Informal document No. **WP.29-150-13**  
(150th WP.29, 9-12 March 2010,  
agenda item 4.2.44.)

Consolidated version for the  
Proposal for the 06 series of amendments to Regulation No. 83  
(Emissions of M<sub>1</sub> and N<sub>1</sub> vehicles)

**ECE/TRANS/WP.29/2010/56**  
**plus**  
**ECE/TRANS/WP.29/2009/134**

"Annex 3

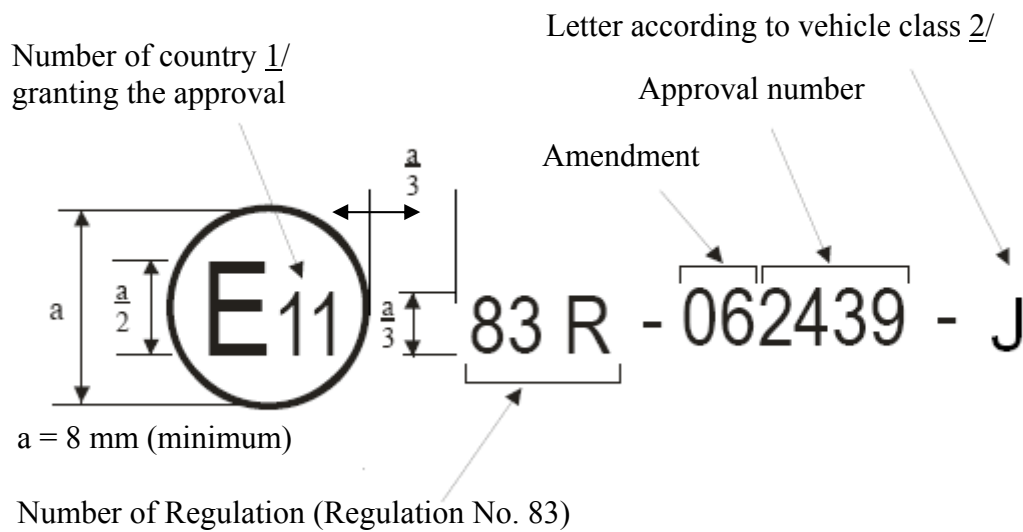
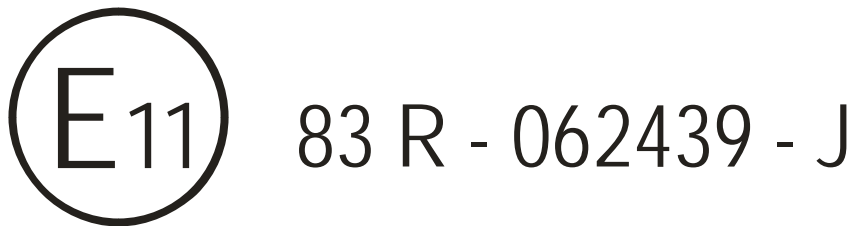
Annex 3, amend to read:

**In the approval mark issued and affixed to a vehicle in conformity with paragraph 4. of this Regulation, the type approval number shall be accompanied by an alphabetical character assigned according to Table 1 of this Annex, reflecting the vehicle category and class that the approval is limited to.**

**This annex outlines the appearance of this mark, and gives an example how it shall be composed.**

The following schematic graph presents the general lay-out, proportions and contents of the marking. The meaning of numbers and alphabetical character are identified, and sources to determine the corresponding alternatives for each approval case are also referred.

### **Standard Bench Cycle (SBC)**

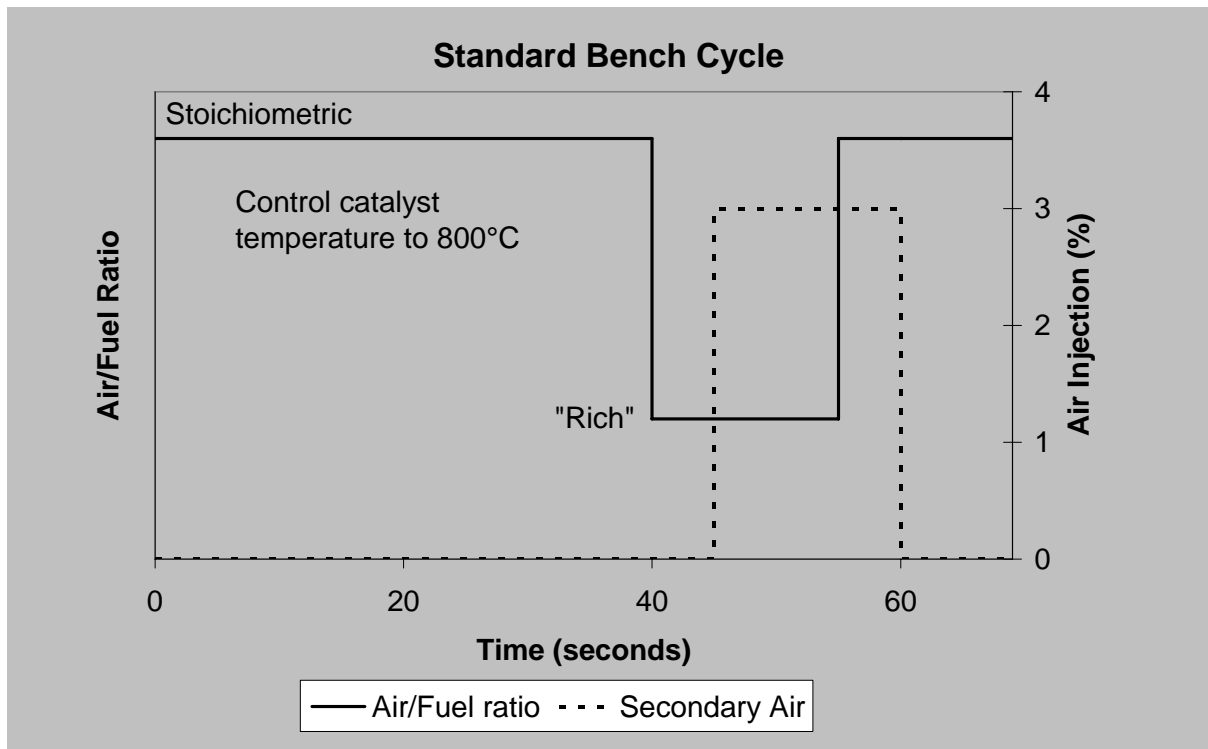
Insert new Appendices 1 to 3 into Annex 9, to read:

**2.1. Catalyst temperature shall be measured in the catalyst bed at the location where the highest temperature occurs in the hottest catalyst. Alternatively, the feed gas temperature may be measured and converted to catalyst bed temperature using a linear transform calculated from correlation data collected on the catalyst design and ageing bench to be used in the ageing process.**

#### **4. Experimentally Determining the R-Factor for Bench Ageing Durability Procedures**

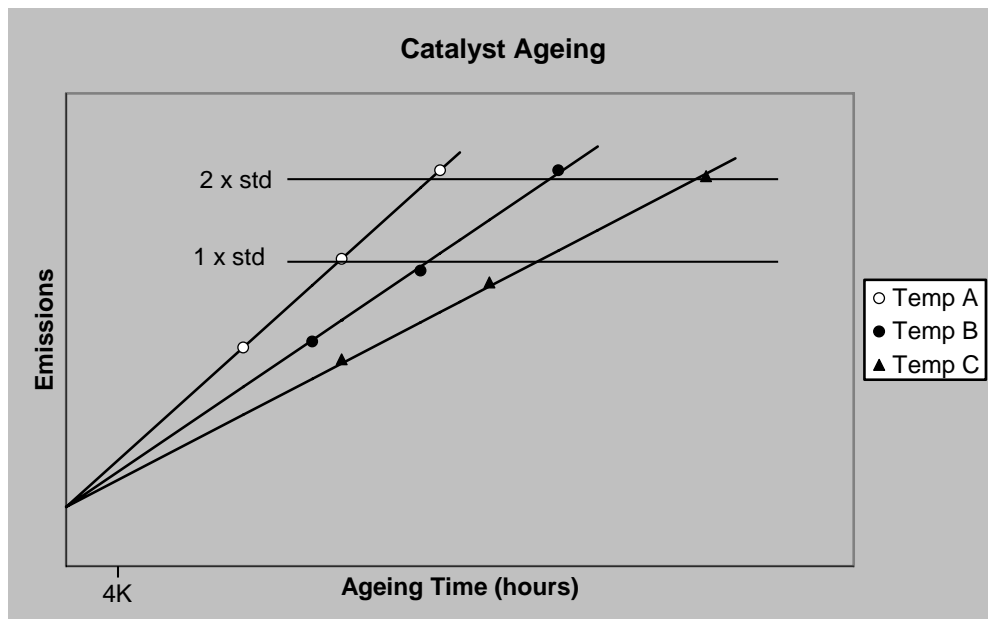
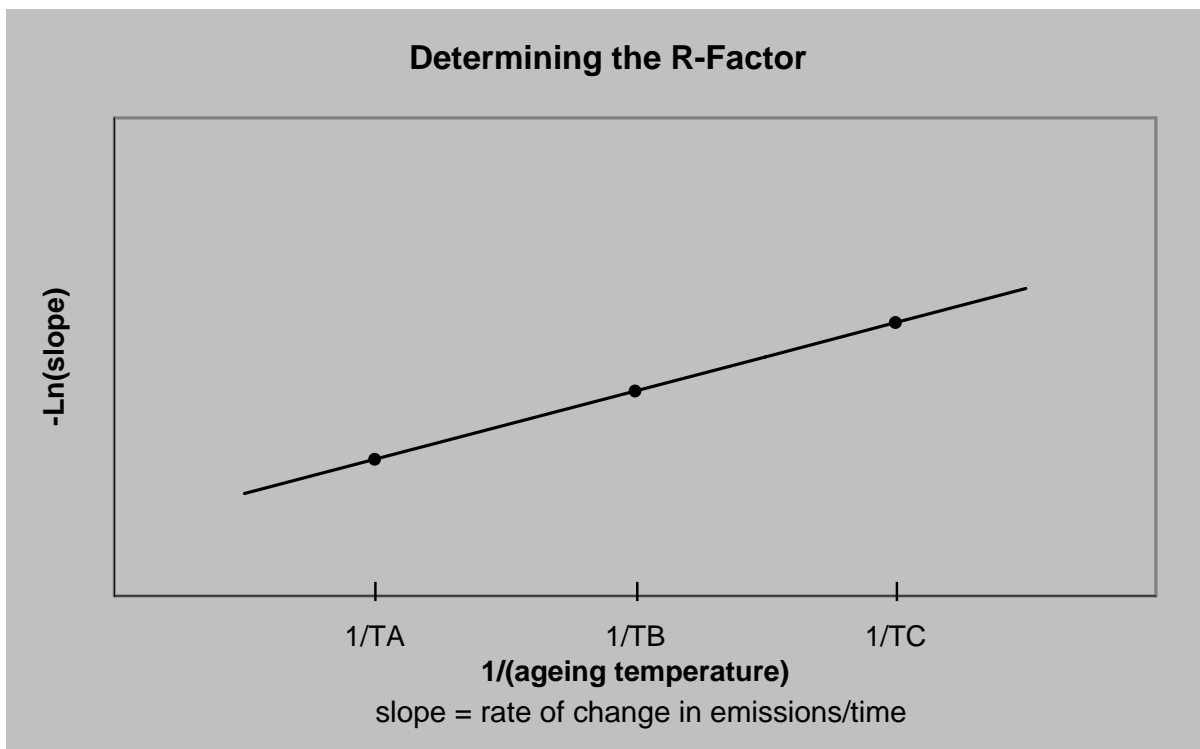
**4.1. The R-Factor is the catalyst thermal reactivity coefficient used in the bench ageing time (BAT) equation. Manufacturers may determine the value of R experimentally using the following procedures.**

**4.1.3. Plot emissions (or catalyst inefficiency) versus ageing time for each catalyst. Calculate the least-squared best-fit line through the data. For the data set to be useful for this purpose the data should have an approximately common intercept between 0 and 6400 km. See the following graph for an example.**

**4.1.5. Plot the natural log (ln) of the slope of each best-fit line (determined in step 4.1.4.) along the vertical axis, versus the inverse of ageing temperature (1/(ageing temperature, deg K)) along the horizontal axis, Calculate the least squared best-fit lines through the data. The slope of the line is the R-factor. See the following graph for an example.**

#### Standard Road Cycle (SRC)

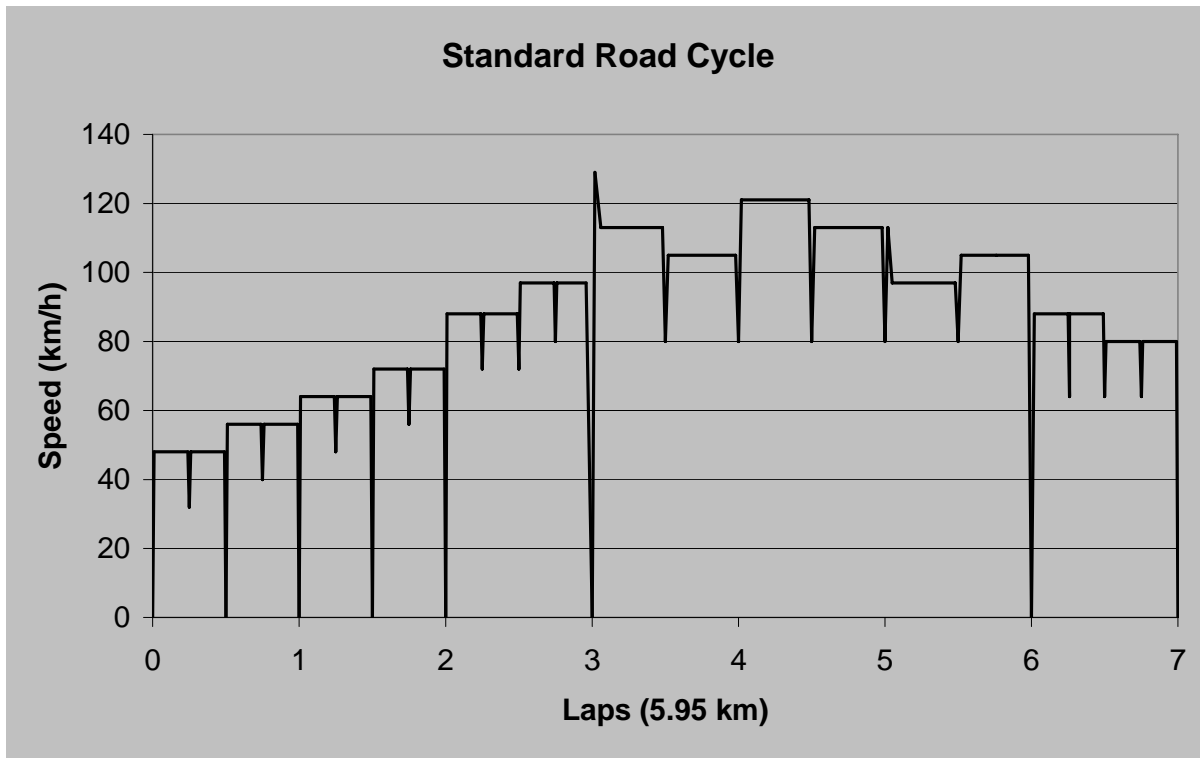
The cycle consists of 7 laps of a 6 km course. The length of the lap may be changed to accommodate the length of the mileage accumulation test track.

The standard road cycle is represented graphically in the following figure:
